Access Compliance Report Public Rights-of-Way (Curb Ramps)

Main Street: DOWNING_ST		Cross Street: VINEYARD_RD		Location:	NW
ADA ID: RPAT211103104339	Ramp Type: Type 4 - Parallel	Initial Pass/Fail: Fail	Overall Compliance: No	Severity Score:	16

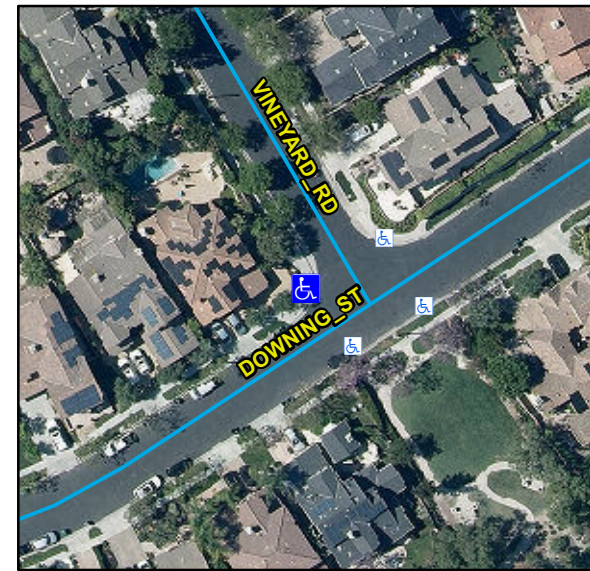
Compliance	Description	Data	Compliance	Description	Data
N/A	Ramp Length LT (in)	105	N/A	Ramp Length RT (in)	110
Yes	Ramp Width LT (in)	54	Yes	Ramp Width RT (in)	54
Yes	Ramp Run Slope LT (%)	1.5	No	Ramp Run Slope RT (%)	10.5
No	Ramp Cross Slope LT (%)	2.3	Yes	Ramp Cross Slope RT (%)	1.6
N/A	Landing Present	N/A	N/A	DWS Provided	N/A
N/A	Landing Length (in)	N/A	N/A	DWS Contrast	N/A
N/A	Landing Width (in)	N/A	N/A	DWS Length (in)	N/A
N/A	Landing Run Slope (%)	N/A	N/A	DWS Full Width	N/A
N/A	Landing Cross Slope (%)	N/A		DWS Offset Type	N/A
N/A	Landing Movement Obstructed?	N/A	N/A	DWS Offset Left (in)	N/A
	Landing Movement Type	N/A	N/A	DWS Offset Right (in)	N/A
N/A	Landing Shared	N/A			
N/A	Clear Space	Yes			
N/A	Clear Space To Crosswalk (in)	N/A			
N/A	Marked Crosswalk 1	No	N/A	Marked Crosswalk 2	No
	Crossing 1 Direction	S		Crossing 2 Direction	E
	Marked Crosswalk 1 Width (in)	N/A		Marked Crosswalk 2 Width (in)	N/A

N/A	Ramp Inside Crosswalk 1	N/A	N/A	Ramp Inside Crosswalk 2	N/A
	Crossing 1 Slope (%)	0.2		Crossing 2 Slope (%)	1.8
	Crossing 1 Cross Slope (%)	2.8		Crossing 2 Cross Slope (%)	1.8
N/A	Gutter Ponding	N/A	N/A	Curb Slope	9.7
Yes	Gutter Lip Height (in)	0		Road Run Slope (%)	2.6
N/A	Gutter Run Slope (%)	N/A		Road Cross Slope (%)	0.4
N/A	Gutter Cross Slope (%)	N/A	No	Perpendicular Joint Present	No
Yes	Overall Surface Condition	Acceptable			
	Cross Gutter Present?	No		Spandrel Present?	No
	Replace Cross Gutter?	N/A		Replace Spandrel?	N/A

Remove & Replace Curb Ramp With Two New Directional Ramps or Equivalent.
